SERVICETEKNOTES

TABLE OF CONTENTS

GMA101A/GMA102A/GMA103/618/4054/4114
NEW HARD COPY BOARD MODIFICATION 44944

Fig. 1: Strobed Hard Copy Board Timing Diagram

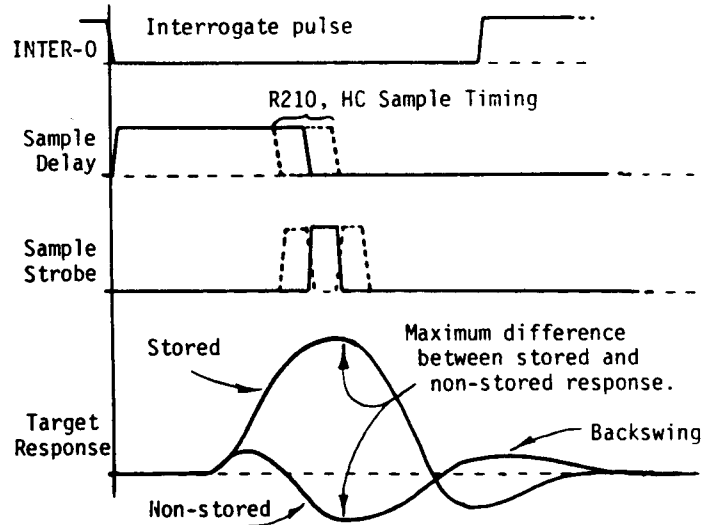
The new board "reads" the CRT target only when a target response is most expected. This reduces the noise produced in the hard copy, especially with CRT targets exhibiting substantial backswing (see the timing diagram). The strobe window can be adjusted with R210, hard copy sample timing. Typically, R210 can be set to midrange and forgotten. Noisy copies may be improved by straying from midrange either clockwise or counterclockwise.

Figure 2

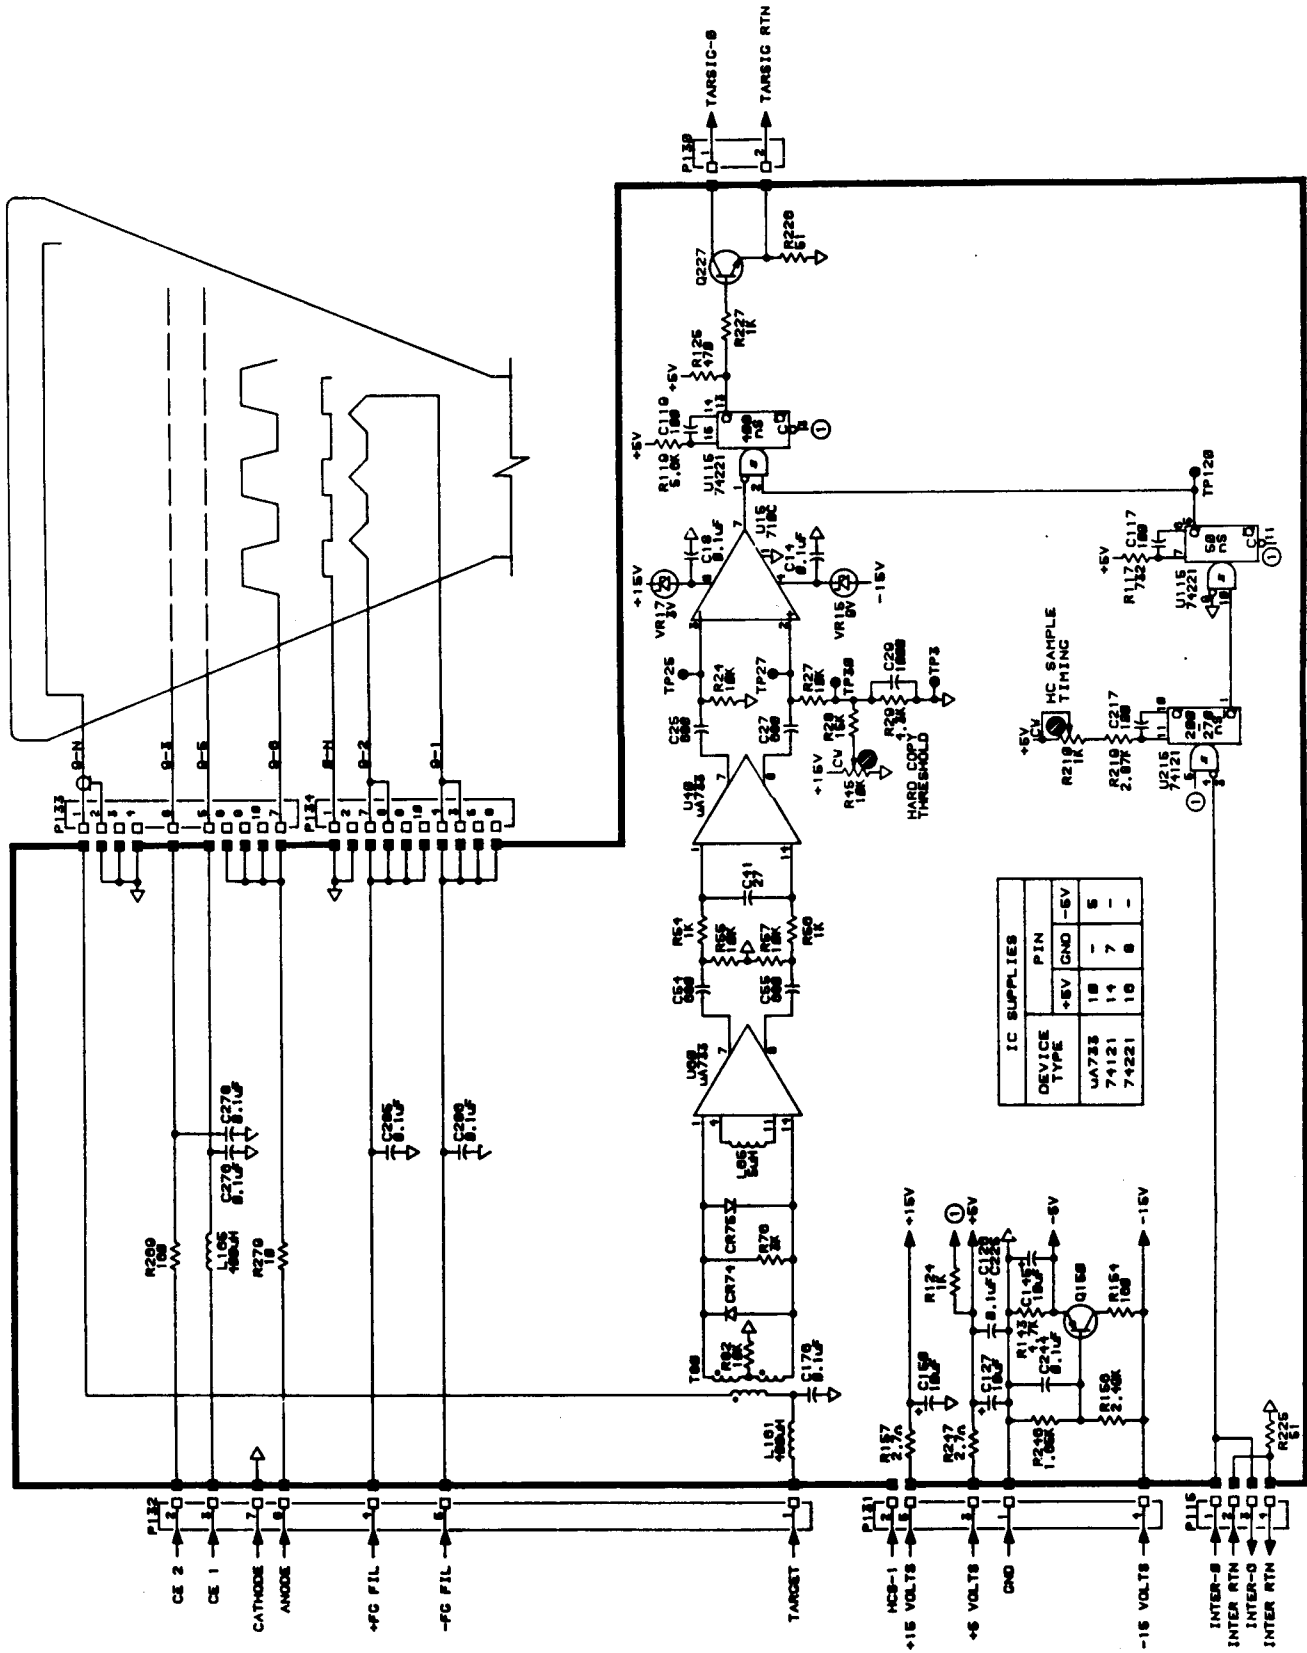
Schematics of the new board and hard copy cable assemblies are given in Figures 2 and 3. Note that the added circuits around U215 (sample timing delay) and U115 (sample strobe) distinguish this board from the earlier 670-3097-XX hard copy board. Note also that the INTER-0 signal produced by the hard copy unit is routed directly to the hard copy board to trigger the strobe. The HCS-1 signal produced on the storage board and necessary with the earlier 670-3097-0X is no longer used.

Figure 3

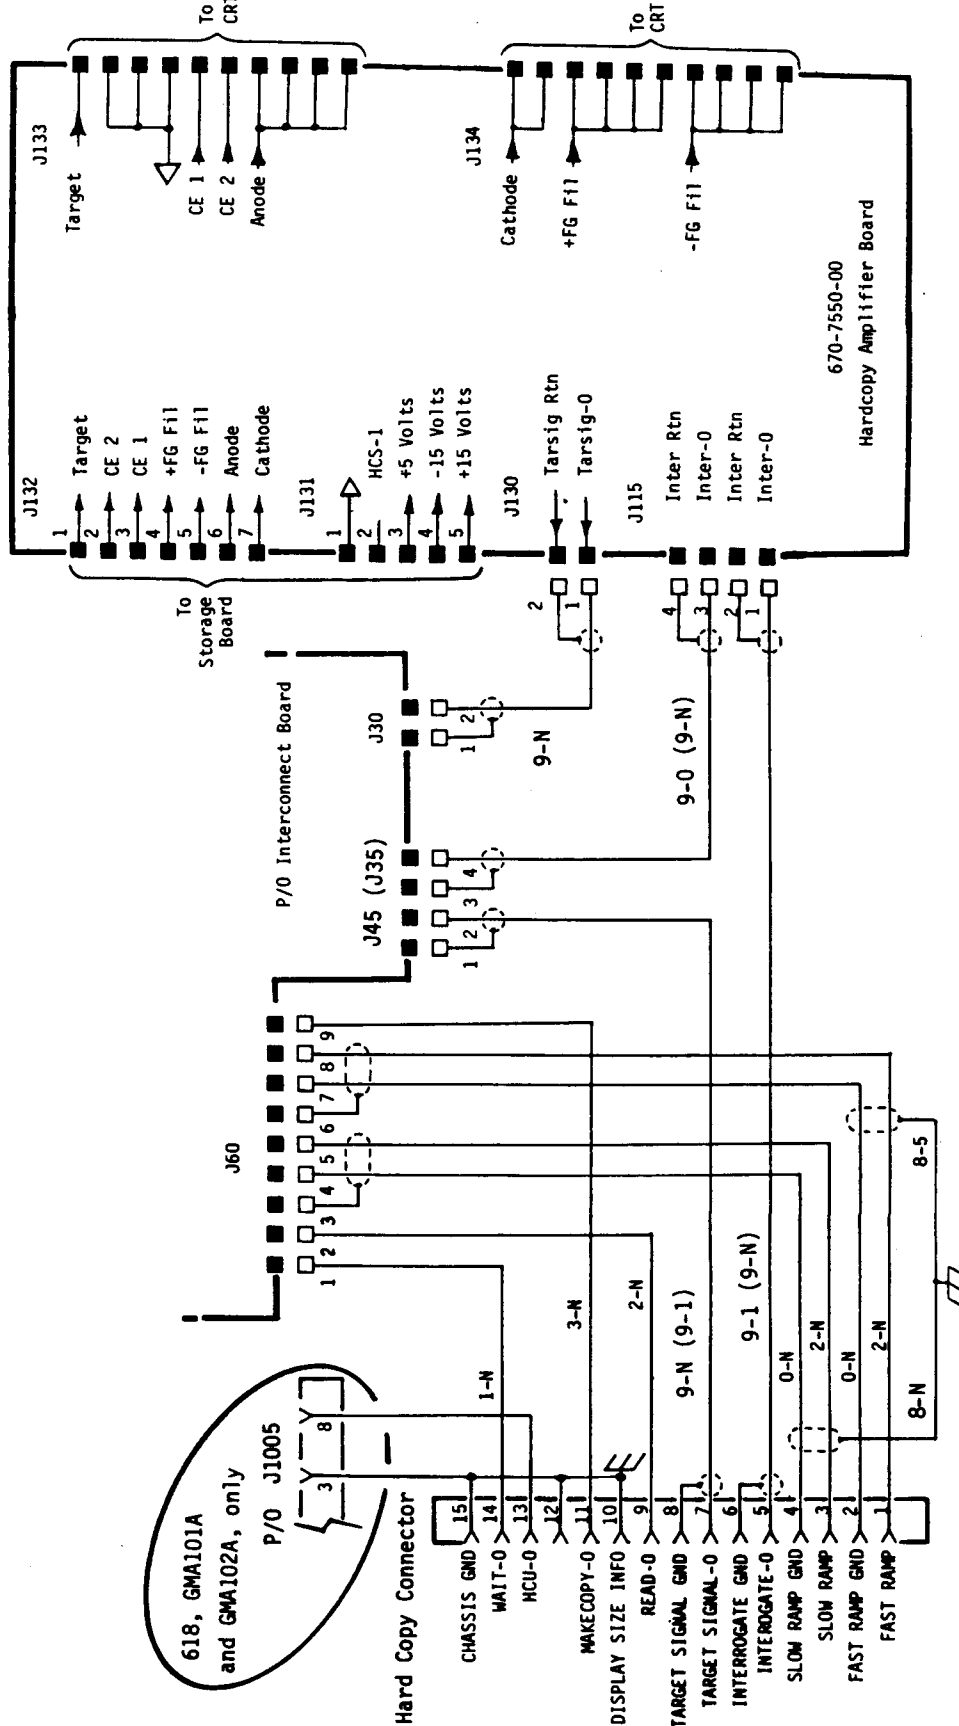
Schematic of the 179-2876-00, 179-2877-00, 179-2879-00 and CM179-2880-00 cable assemblies used with the 670-7550-00 strobed hard copy board. Numbers in parens apply to some 4054 products only.

A38 —Optical Pulse Generator circuit board.

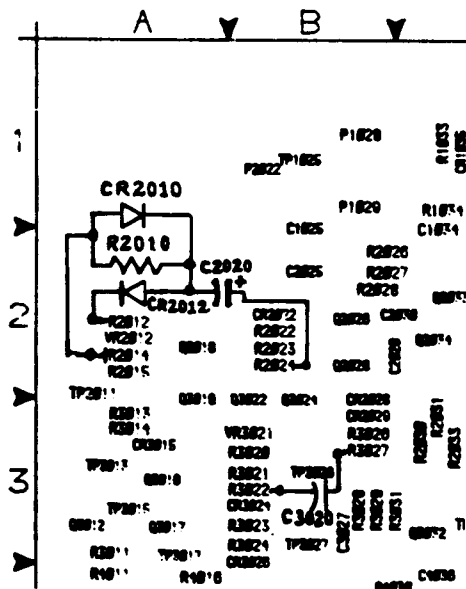
1. To top of Optical Pulse Generator Circuit Board Assy 670-7153-00, add a 15 uf capacitor (C2020) with the positive lead at the +5V end of a 100K resistor (R2024). Connect the negative lead of C2020 to the anode lead of an added diode (CR2012) and connect cathode lead of diode (CR2012) to junction of 12K resistor (R2012) and the emitter of transistor Q2018.

Connect an added diode (CR2010) and added 100K resistor (R2010) in parallel and connect the cathode end of pair at the junction of the negative lead of 15 uf capacitor (C2020) and anode lead of diode (CR2012).

Connect the anode lead of diode (CR2010), which is paralleled with resistor R2010, to the ground lead of a 100K resistor (R2014).

2. On back of the same circuit board assembly, add a .1 uf capacitor (C3020) between junction of a 360Ω resistor (R3022) and a 1.37K resistor (R3024) and the ground lead of a 20K resistor (R3027).

The above parts are located on the A38 Optical Pulse Generator board and shown on diagram 2 OPTICAL PULSE GENERATOR.

FL7705 is added as shown in partial diagram 18

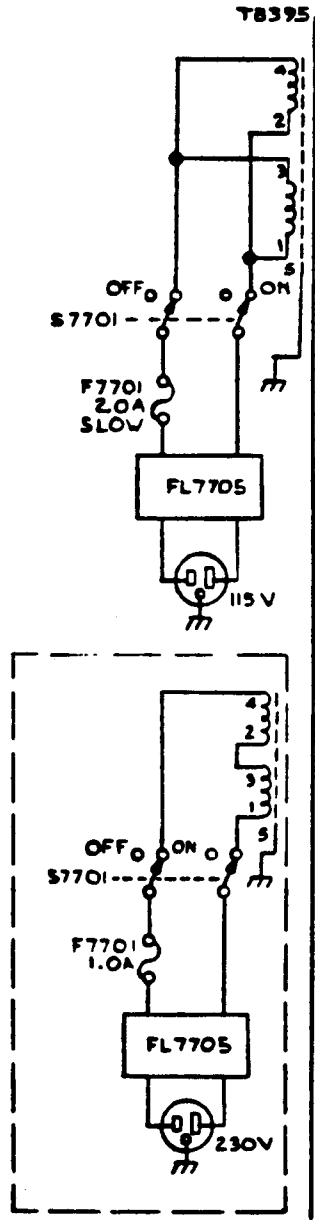
FL7705	119-1536-00	FILTER,RFI: 3A, 250 VAC, 50/60HZ
--------	-------------	----------------------------------

FL7705 is added as shown in partial diagram 16

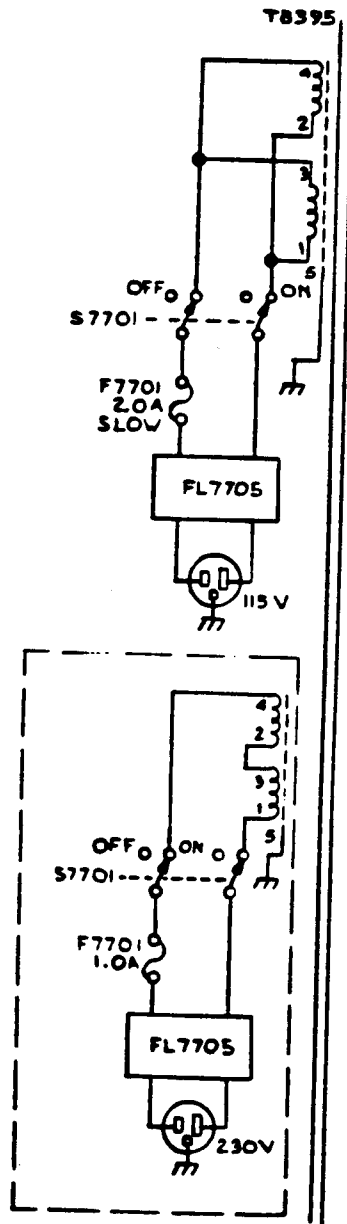
FL7705	119-1536-00	FILTER,RFI: 3A, 250 VAC, 50/60HZ
--------	-------------	----------------------------------

Figure 1

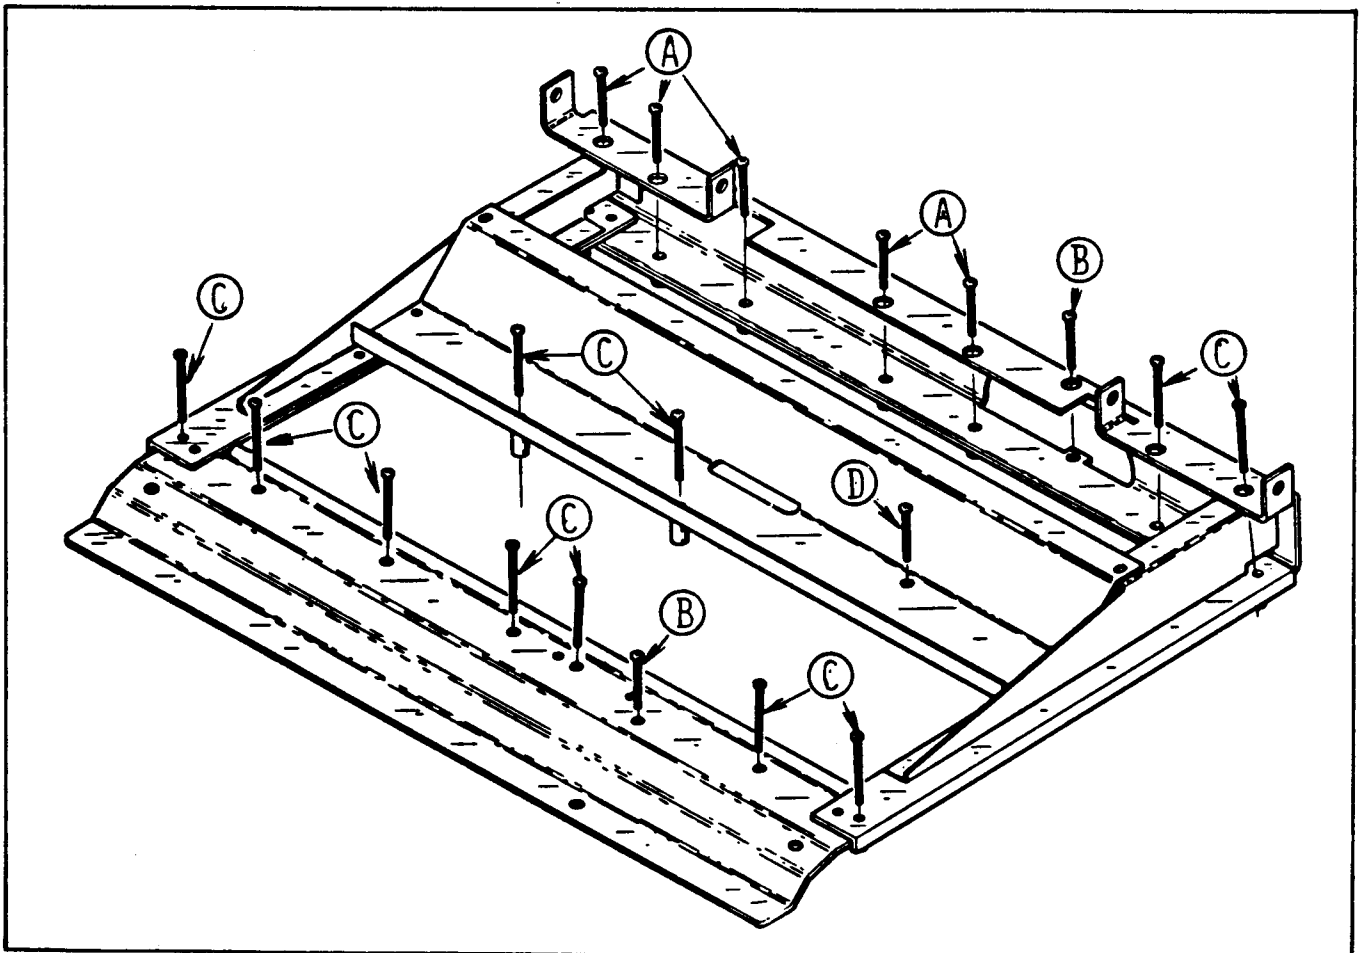
Questions have filtered in from different field personnel concerning the length and placement of the screws which hold the CPU sandwich to its frame assembly. The figure below shows the frame assembly, the screws and the holes which the screws are inserted through. Note circled alpha characters, each denote a different length screw. Following the figure is a table for cross-referencing the index character to screw length.

Note that there are two "D" type screws listed. On the 4054A this screw goes through the ALU board and into the I/O board, whereas on the 4054 it only screws to the ALU board.

<u>Index Character</u>	<u>Screw Length</u>	<u>Tektronix P/N</u>	<u>Quantity</u>	<u>Comments</u>
A	1.375"	211-0525-00	5	4054/54A
B	1.0"	211-0517-00	2	4054/54A
C	1.5"	211-0553-00	11	4054/54A
D	0.375"	211-0559-00	1	4054 only
D	1.750"	211-0530-00	1	4054A only
